# THE BELT RAILWAY COMPANY OF CHICAGO

## CORA Update 2026-001

Effective 0001 CST, February 23<sup>rd</sup>, 2026

# Kenton Line

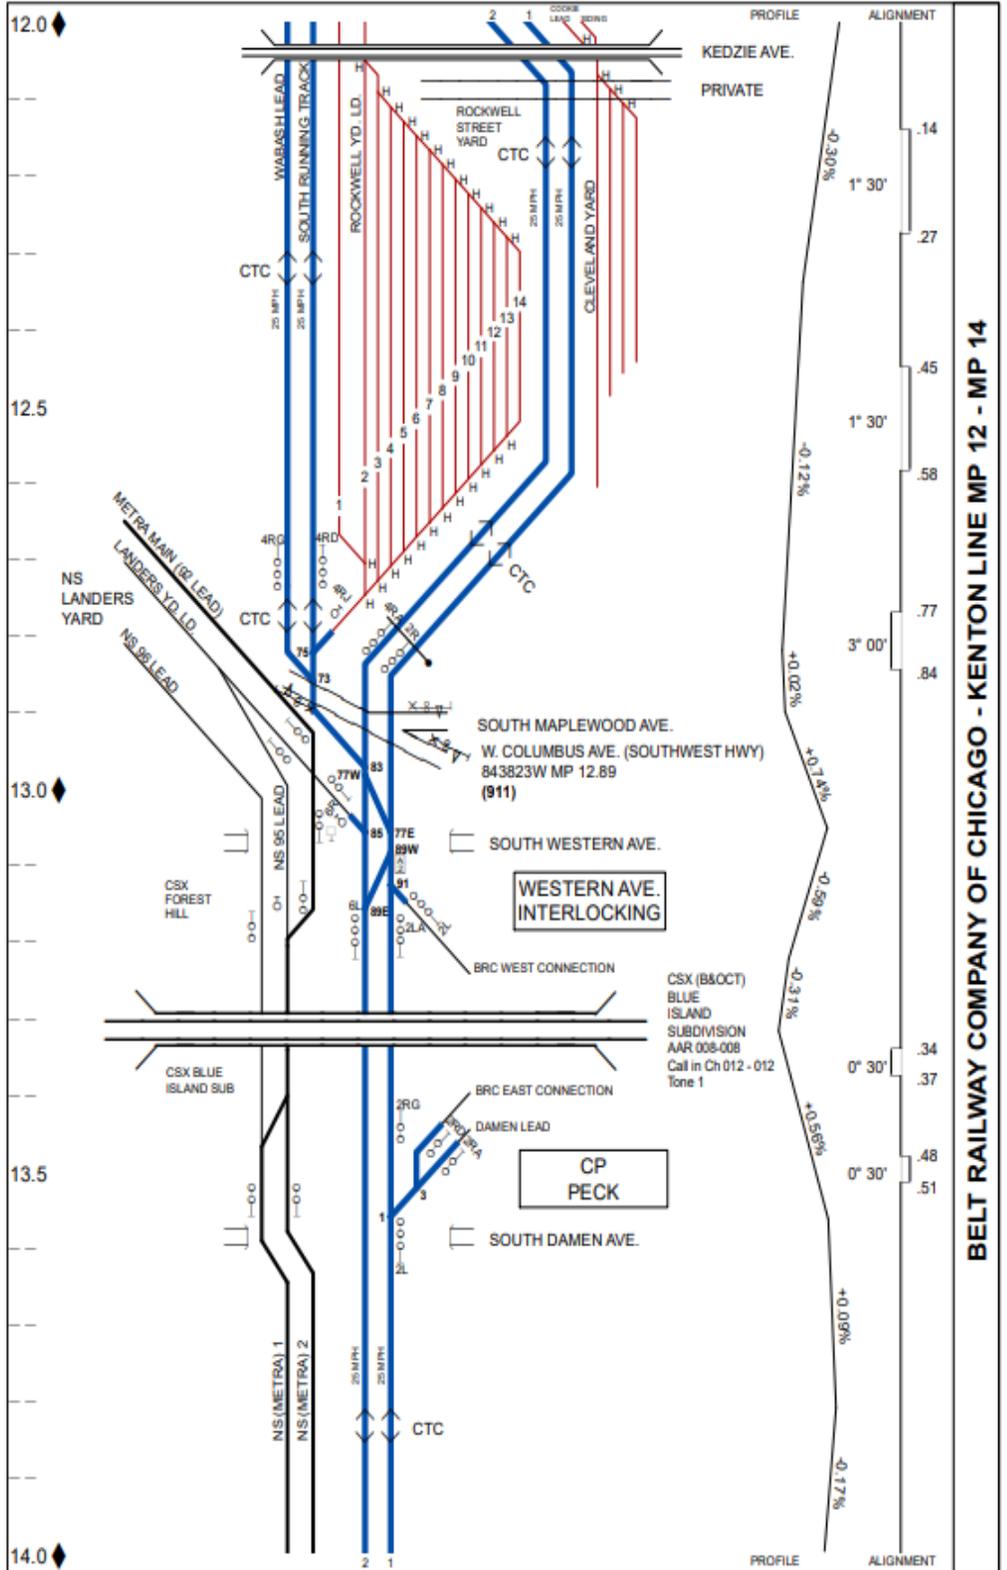
At the Western Avenue Interlocking, the location of the following signal has been changed.

- 2LA signal located at MP 13.2 on MT 1 which governs Northbound movement is now located 250 feet south of its previous location, it remains a High-Mast Signal.
- Previous instructions issued pertaining to southbound trains holding at Western ave Interlocking until a favorable signal is displayed at Forest Hill Interlocking, are no longer in effect.

**The Forest Hill Interlocking located at MP 13.4 has been retired from service**

The Railroad Crossing at Grade on MT 1&2 located at MP 13.3 has been removed and is now straight rail.

At the Forest Hill Interlocking, the following signals are no longer in service.

- Northbound movement – 12 Signal & 18 Signal
- Southbound movement – 10 Signal & 16 Signal
- CSX Connection (New Wye) – 14 Signal

## **New Control Point Placed in Service named “CP-Peck”**

**CP-Peck** has been placed in service, the Control Operator for **CP-Peck** is the BRC South Dispatcher. **CP-Peck** now governs all train movements on BRC MT 1 at MP 13.50, including movements to/from CSX at the former “New WYE” connection.

- **2RG** Signal located at MP 13.42 will govern Southbound movement on **MT 1** and will display the following, Rule 9.1.1, 9.1.3, 9.1.11, 9.1.15
- **2L** Signal located at MP 13.55 will govern Northbound movement on **MT 1** and will display the following, Rule 9.1.1, 9.1.3, 9.1.7, 9.1.9, 9.1.15, 9.1.16
- **2RD** Signal located on the left side (as viewed by approaching train) of the “**BRC East Connection**” track governing movement from the CSX to BRC MT 1 will display the following, Rule 9.1.1, 9.1.3, 9.1.7, 9.1.10
- **2RA** Signal Located on the left side (field side) of the “**Damen Lead**” track governing movement from the CSX to BRC MT 1 will display the following, rule 9.1.1, 9.1.3, 9.1.7, 9.1.10

Please refer to the updated Linear Profile at the end of CORA Update, which reflects all changes between MP 12.0 & MP 14.0 on the BRC Kenton Line.

BELT RAILWAY COMPANY OF CHICAGO - KENTON LINE MP 20 - MP 21

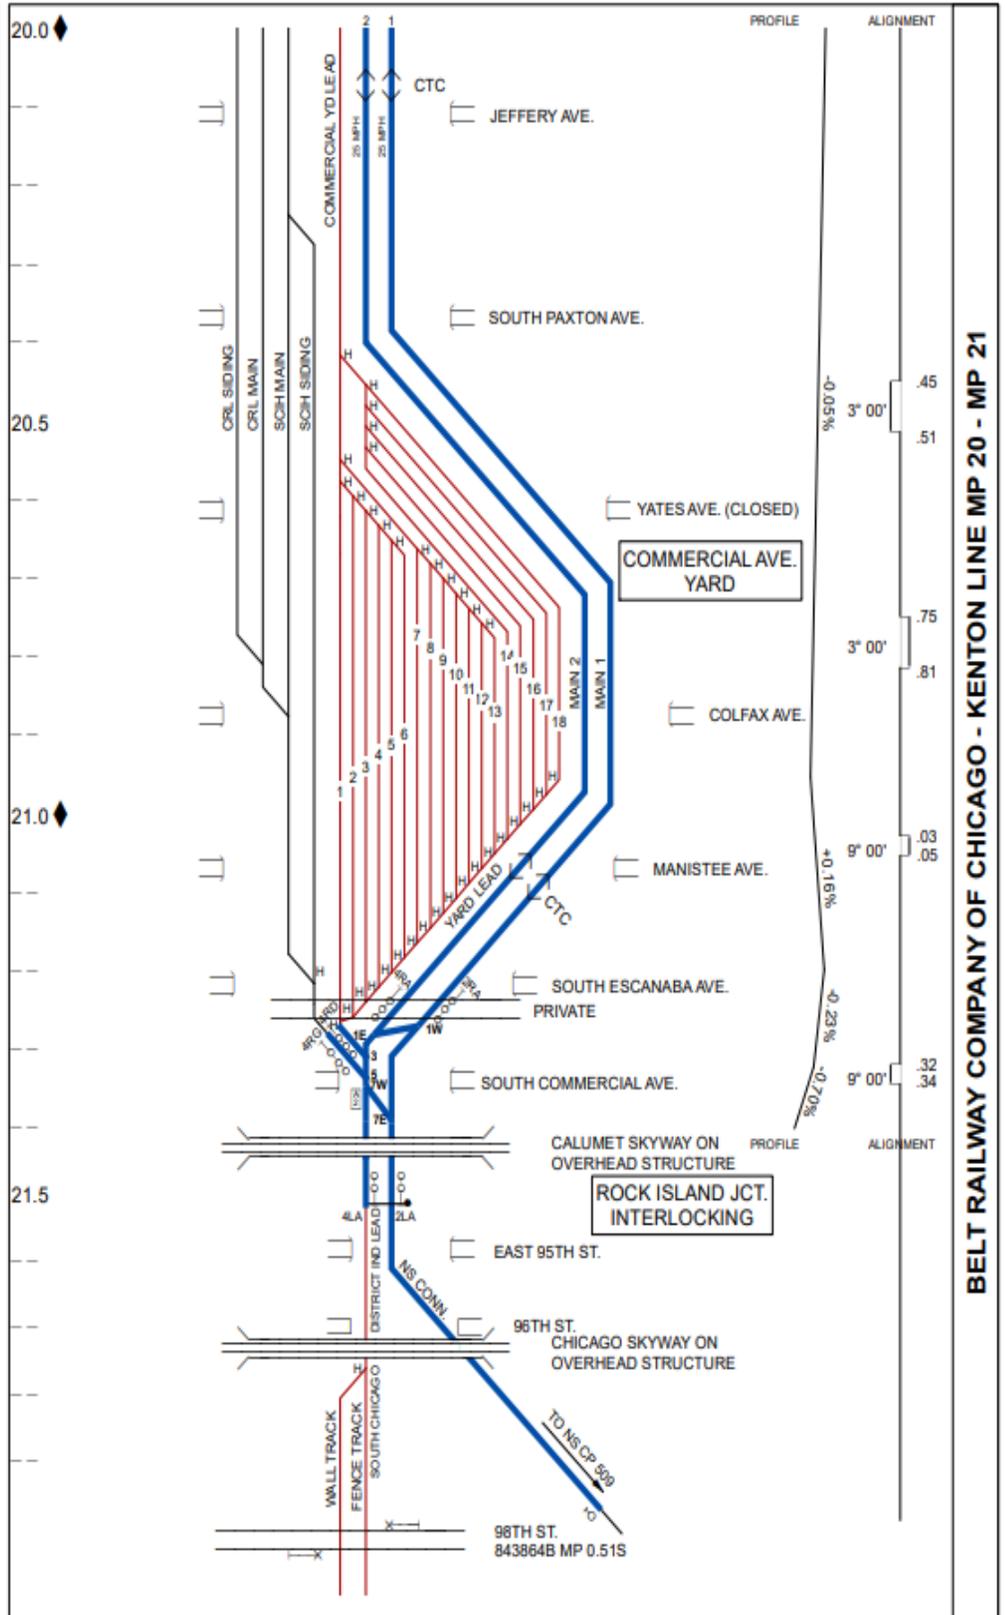
Effective Wednesday March 6<sup>th</sup> at 1600 the signals for governing Northbound movement at the Rock Island Jct. Interlocking will be relocated and be displayed on a cantilever mast.

- The 2 LA Signal which governs movement northward from the NS Connection track at Rock Island Jct will be relocated approximately 82 feet north from its current position and will now be a two-aspect display mounted on the cantilever mast.
- The 4LA signal which governs movement northward from the South Chicago District Industrial Lead at the Rock Island Jct Interlocking has been moved approximately 282 feet to the south, it is now a two-aspect display mounted on the cantilever mast.

The previous three aspect stand-alone signal mast for the NS Connection track and the South Chicago Industrial Lead Track will be removed from service.

Signal Aspects added to Southbound signals at Rock Island Junction.

The 2RA signal will now be able to display an APPROACH MEDIUM aspect.

The 4RA-4RD-4RG signals will now be able to display a MEDIUM CLEAR aspect.

All signals Governing Movement at Rock Island Junction are two aspect signals.
